Response to MassDevelopment with Respect to
The Residences at South Brookline

RE: Chapter 40B Comprehensive Permit

Project Name: The Residences at South Brookline
Location: Independence Drive, Brookline, MA
Number of Proposed Units: 271
Subsidizing Agency: Massachusetts Development Finance Agency
Applicant: The Residences of South Brookline, LLC
Development Company: Chestnut Hill Realty

Figure 15: Typical Building-Landscape-Road Sections
Scale: 1"=30'

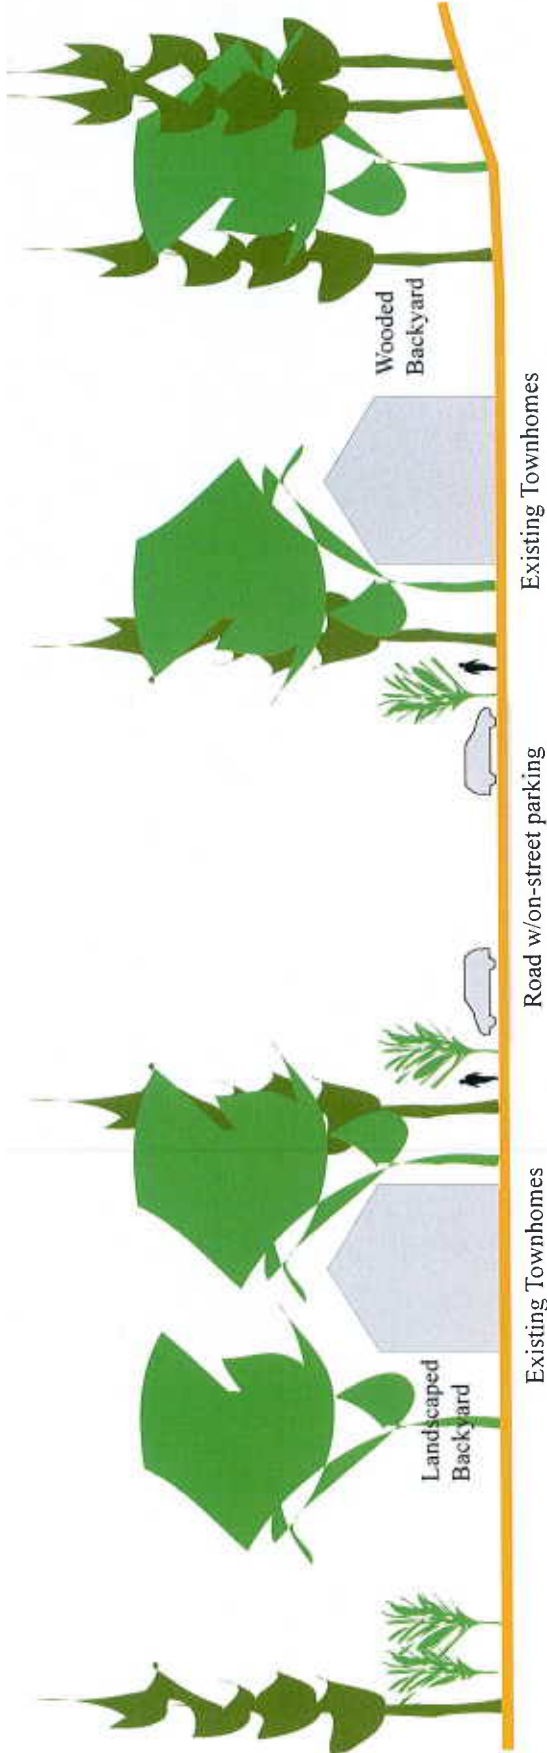
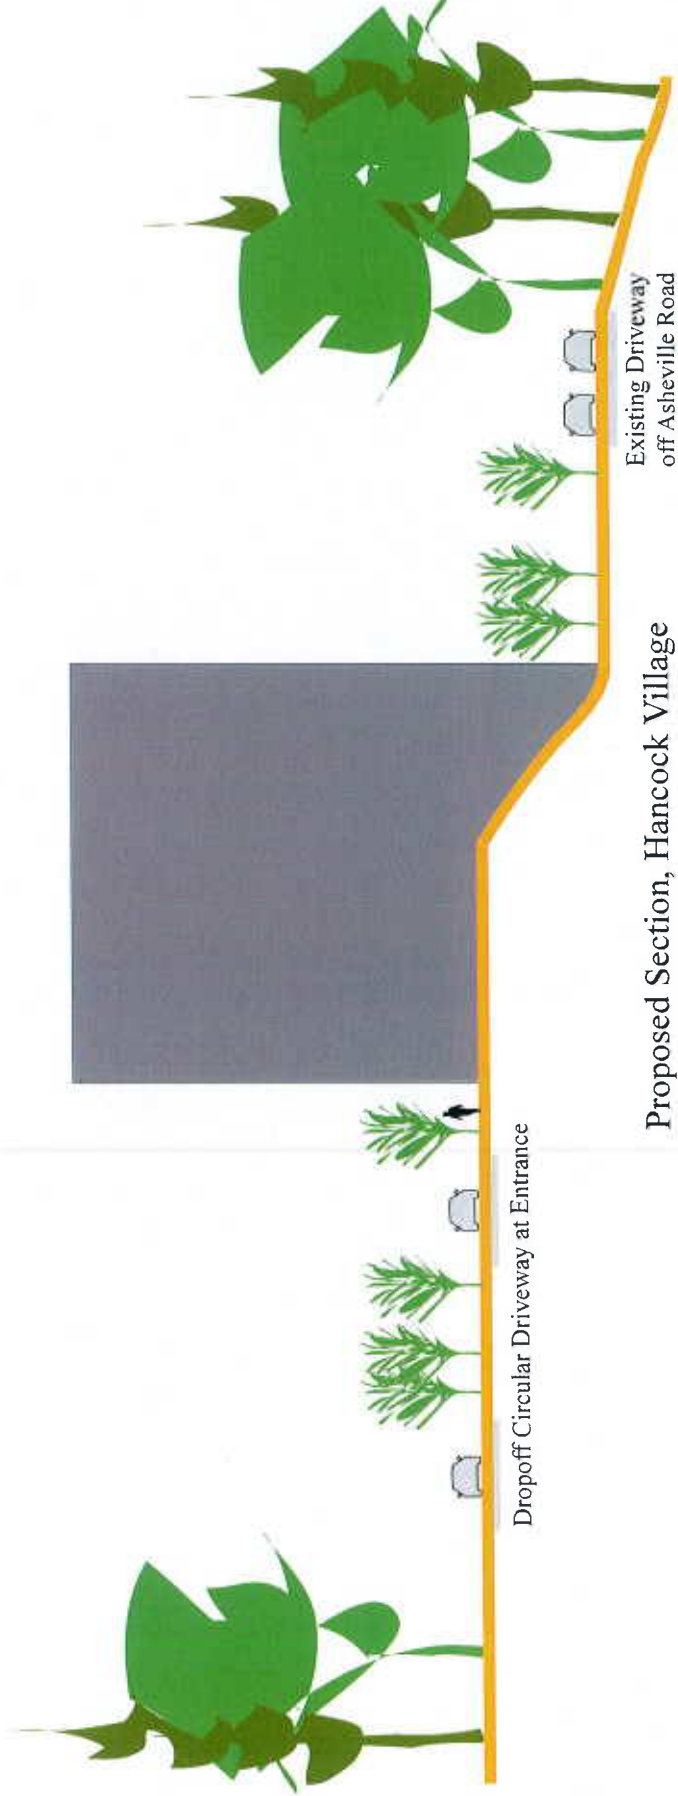
parkway listed on the National Register of Historic Places. Refer to Typical Building — Landscape — Roadway Section (**Figure 15**), highlighting how the relationship between the height of proposed buildings to the width of the streets (with little room for landscaping in between) would be significantly different from the existing street patterns, both inside and outside the boundaries of Hancock Village. Unlike the single-family homes and the townhomes of modest scale set on narrow streets, with landscaped front yards and separated pedestrian access, the proposed project includes large buildings sited without any reference to existing building-to-street patterns.

Hancock Village- Proposed Site Plan July 15, 2009

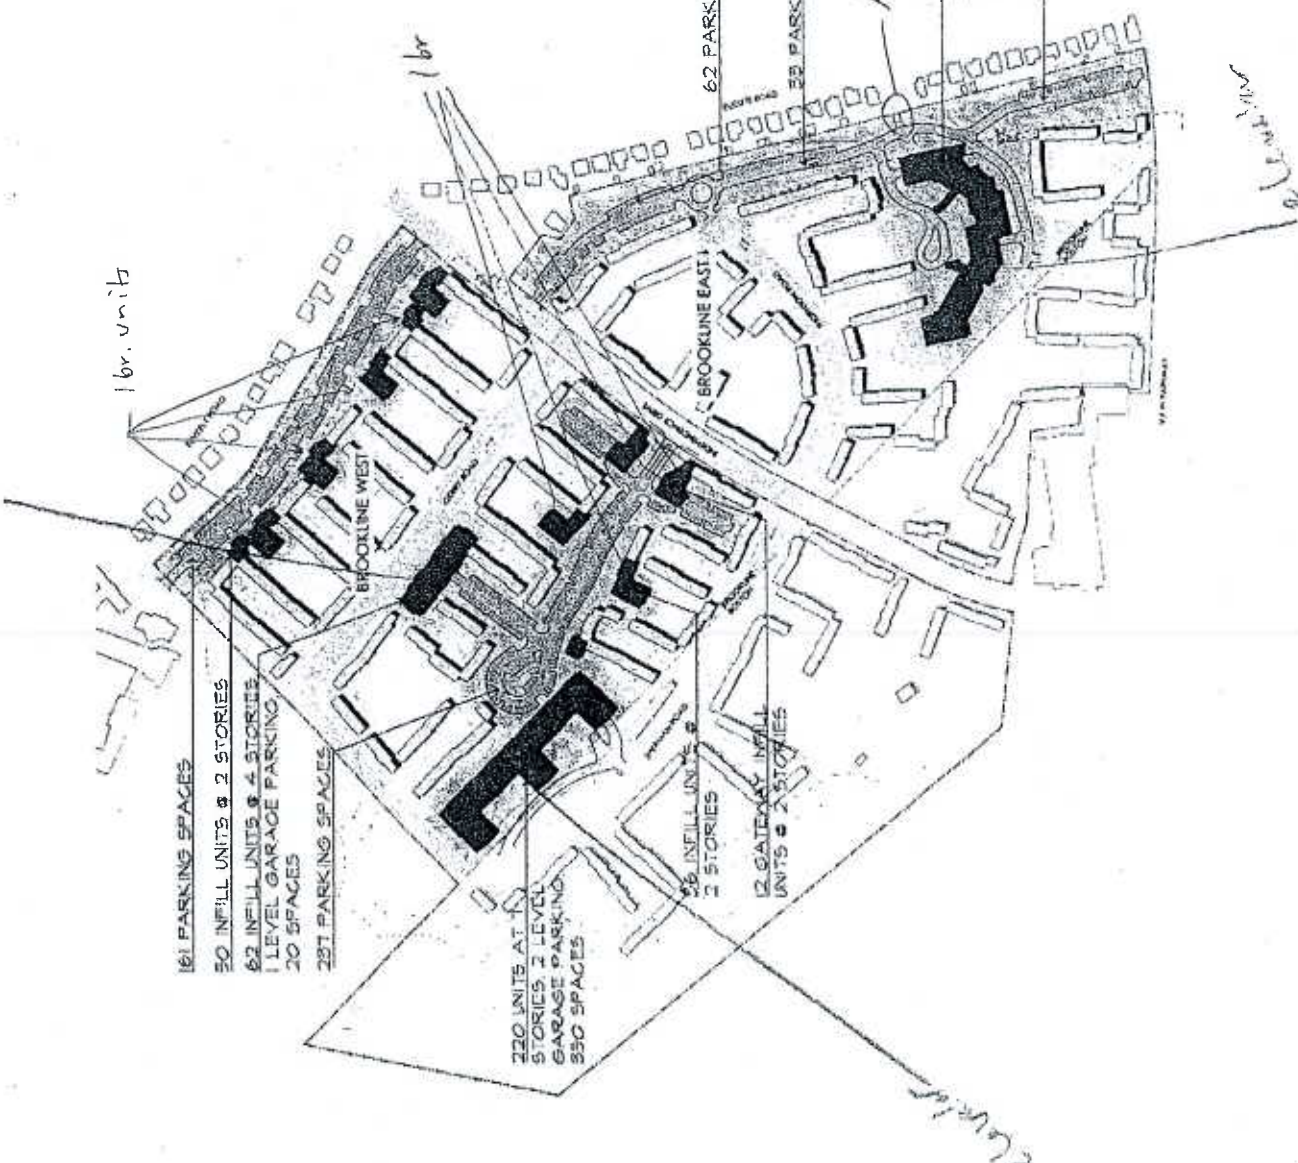
- All proposed units are flats no town homes. Two story buildings will be walkups; all other buildings will have elevators.
- Proposed plan will have no 3 bedroom units - *good or bad?*

*Assumes
change
to parking
requirement?*

What if zone change? Higher Aff?
